**HAI TISEEN PRIMARY HEALTHCARE CENTER  
TAMEEM PROVINCE, IRAQ**

**SUSTAINMENT ASSESSMENT**

**SIGIR PA-08-158  
APRIL 16, 2009**

SUBJECT: Report on the Hai Tiseen Primary Healthcare Center, Kirkuk, Iraq (SIGIR  
Report Number PA-08-158)

Site Photo 5. Two generators providing primary and emergency backup power for the PHC

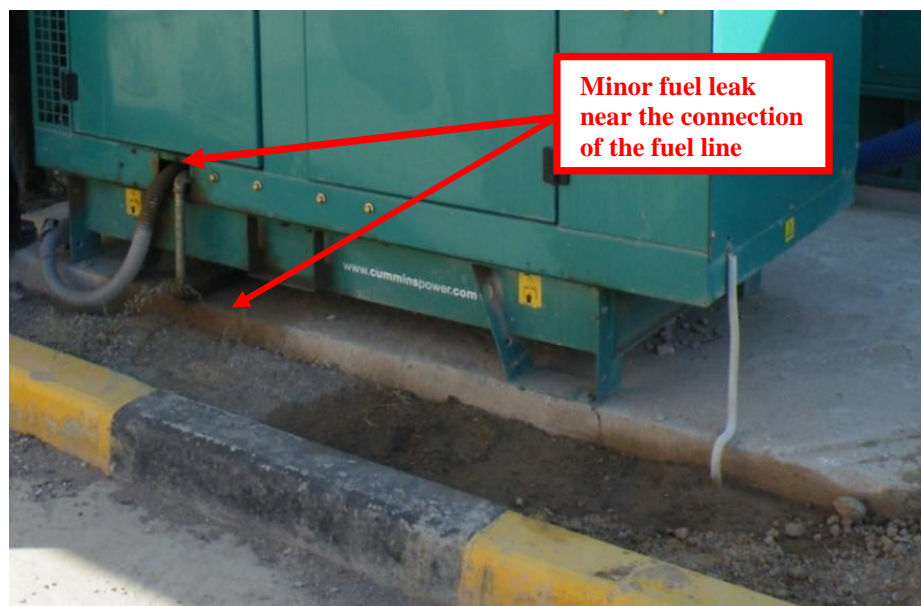
The Hai Tiseen PHC is connected to the national grid; however, the national grid is unreliable and provides approximately four hours of electricity per day. The primary source of electricity for the facility is provided from one of the two generators located on site (Site Photo 5). The larger generator, 1-megawatt (MW), is used for primary power; while the smaller generator, 500-kilovolt (kV), is for emergency backup. During the site visit, the generators appeared to be relatively clean and in working order. SIGIR verified the generators' specifications via the faceplates.

Since the Hai Tiseen PHC is connected to national grid power, an automatic transfer switch is critical to transfer to generator power once electricity from the national grid is lost. The PHC design incorporated the use of an automatic transfer switch. SIGIR verified the installation of the automatic transfer switch, which according to the administrator, was functioning correctly.

**Site Photo 9. Second dental chair with stagnant water**

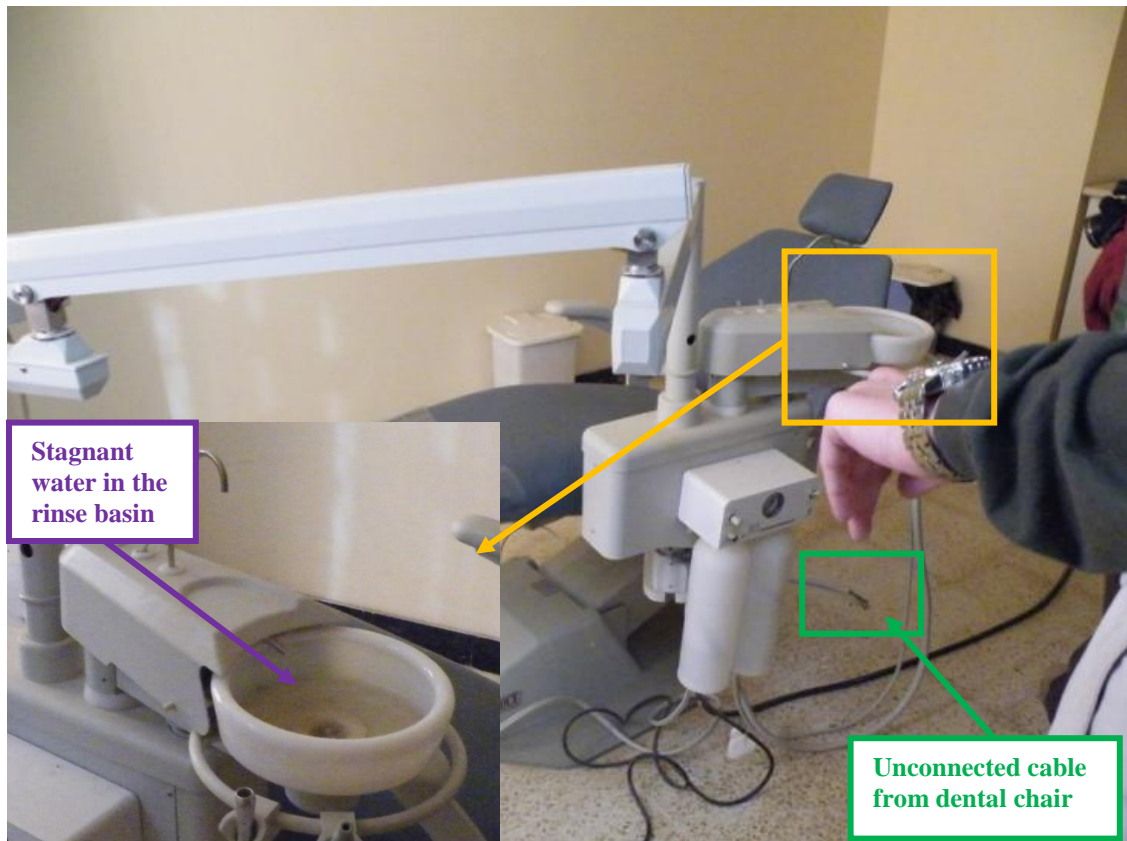
During the site visit, SIGIR observed that the dental chairs were installed. While one dental chair appeared to be in use (Site Photo 8), the second dental chair appeared to have a plugged drain with stagnant water in the rinse basin (Site Photo 9). During the inspection, SIGIR observed a dentist treating a patient while using the working dental chair.

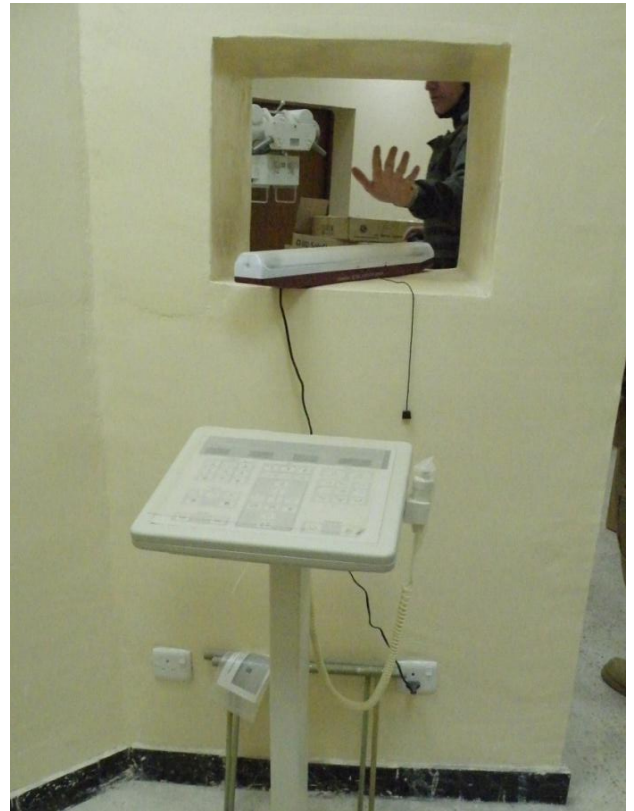
The PHC contract included medical imaging capabilities, specifically an x-ray room and equipment. SIGIR observed that the x-ray equipment was installed (Site Photo 10); however, according to the administrator, the contractor did not verify the equipment was operational. In addition, the administrator stated the facility's staff did not have the technical capability to operate the x-ray equipment; consequently, the facility cannot offer any x-ray services to its patients. Currently, the PHC uses the x-ray room as a medical supply storage room.

Due to the x-ray equipment emitting low levels of radiation, radiation shielding is required to protect the PHC's personnel and patients. The initial design required mass concrete walls with lead lining, lead lined doors, and a leaded glass observation window to provide radiation shielding.

In the 18 July 2007 acceptance letter, one of the noted deficiencies was "x-ray machine," which was to be "installed later." SIGIR noted that the contractor did install the x-ray machine; however, the contract-required installation of a leaded-glass observation window was not installed nor was it noted as a deficiency on the acceptance letter (Site Photo 11). In addition, SIGIR noticed that the contractor installed x-ray room exterior door and darkroom doors appeared to be standard wooden doors. The inspection team could not verify the presence of lead lining on the concrete walls.
